Moccasin
Engineering +
Records Building

**Civic Design Review
Phase III**

August 2026

East Facade Design Revision

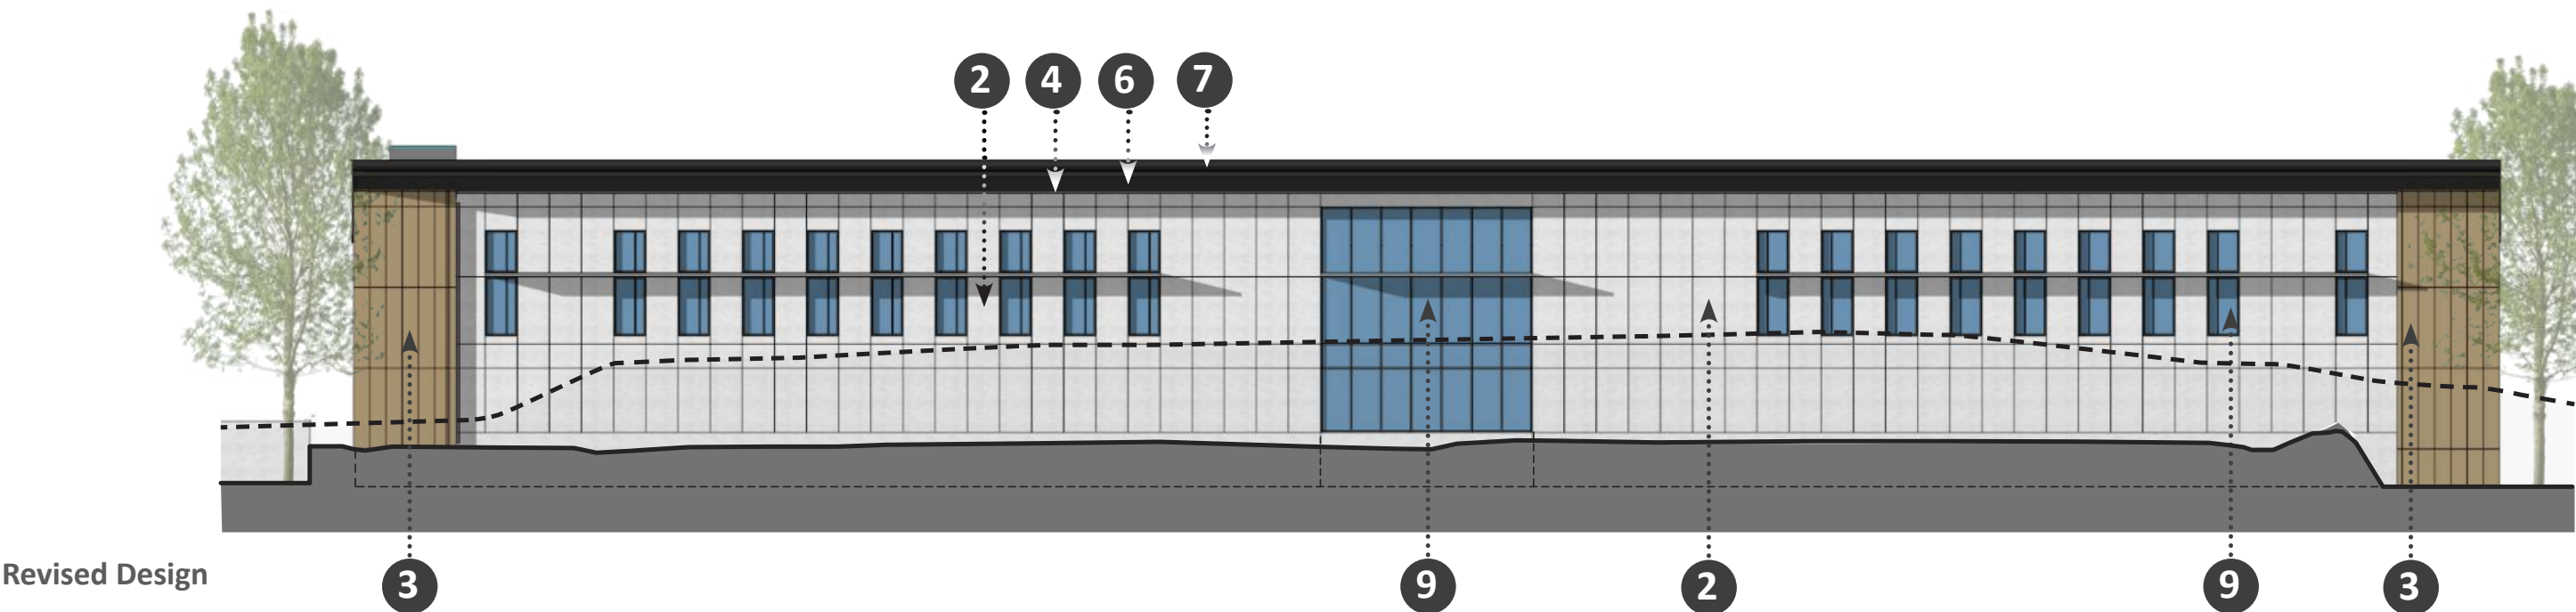
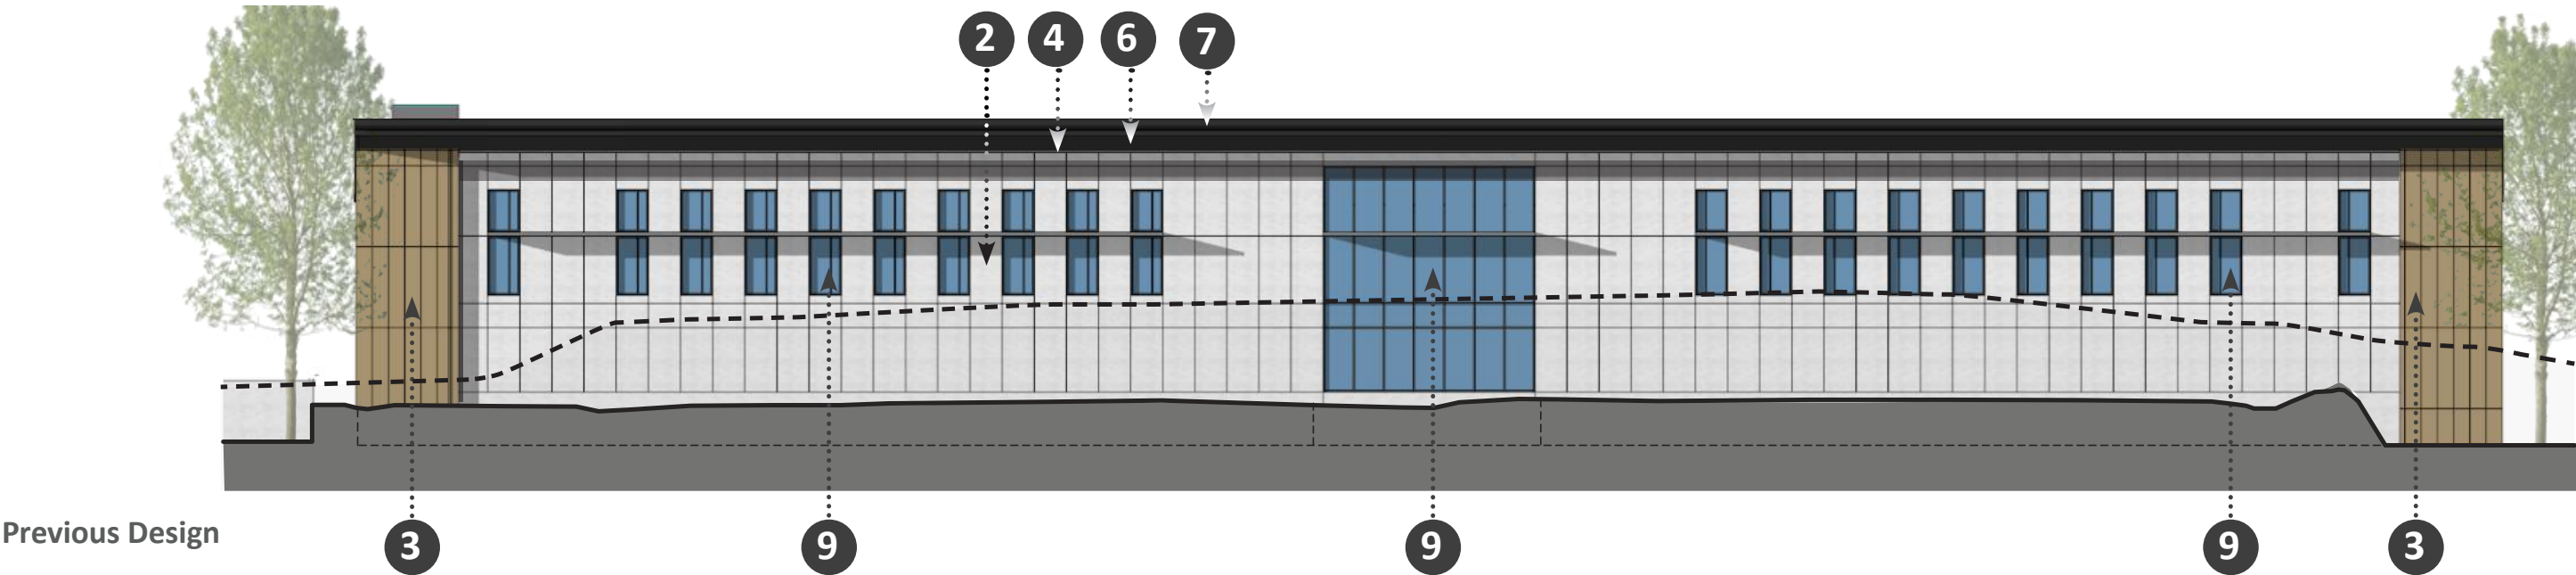
- Are there plans for providing bird-proofing at the sunshades at the East elevation?
- Level 2 columns conveyed to be too slender even though they are steel columns. Preferred the previous brown color of columns.
- Recommended that the concrete seating to be more articulated and design to pick up on the precast column articulation.

- Bird-proofing will be accommodated at the sunshades.
- Column sizes increased from 4 inch HSS to 6 inch HSS.
- Formliner added to the concrete seating.
